Access Compliance Report

Public Rights-of-Way

(Curb Ramps)

Intersection ID: 25628	Main Street: WINDSWEPT_DR	Cross Street: PINEVILLE-MATTHEWS_RD	Location: SE
ADA ID: BD1898418BFC	Ramp Type: Perp	Initial Pass/Fail: Fail	Overall Compliance: No
Severity Score: 21.25			
Codes/Mitigation Info/Possible Solution		Field Measurements/Component Compliance

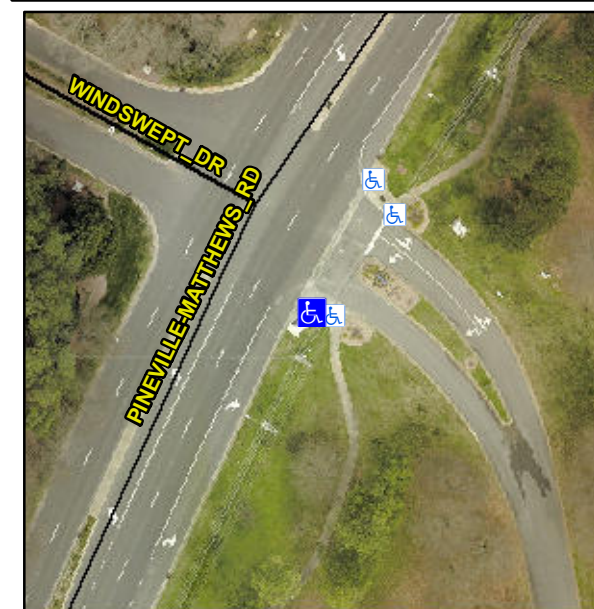
Not Found, R304.5.1, R304.2.2

Compliance	Description	Data	Compliance	Description	Data
N/A	Ramp Length (in)	27.0	No	Ramp Slope (%)	8.6
No	Ramp Width (in)	44.0	Yes	Ramp XSlope (%)	2.0
N/A	Flare Type LT	N/A	N/A	Flare Type RT	N/A
N/A	Flare Slope LT (%)	N/A	N/A	Flare Slope RT (%)	N/A
N/A	Flare Traversable LT?	N/A	N/A	Flare Traversable RT?	N/A
N/A	Landing Length (in)	N/A	N/A	DWS Provided?	N/A
N/A	Landing Width (in)	N/A	N/A	DWS Contrast?	N/A
N/A	Landing Slope (%)	N/A	N/A	DWS Length (in)	N/A
N/A	Landing X Slope (%)	N/A	N/A	DWS Full Width?	N/A
N/A	Landing Curb? (Y/N)	N/A	N/A	DWS Offset (in)	N/A
N/A	Shared Landing?	N/A			
N/A	Gutter Ponding?	N/A	N/A	Gutter Slope (%)	N/A
N/A	Gutter Lip Ht (in)	N/A	N/A	Gutter X Slope (%)	N/A
N/A	Painted X Walk1?	No	N/A	Painted X Walk2?	N/A
	X Walk 1 Direction	To NW		X Walk 2 Direction	N/A
N/A	X Walk 1 Width (in)	N/A	N/A	X Walk 2 Width (in)	N/A
	X Walk 1 Slope (%)	6.1		X Walk 2 Slope (%)	N/A
	X Walk 1 X Slope (%)	1.2		X Walk 2 X Slope (%)	N/A

Remove & Replace Entire Ramp.
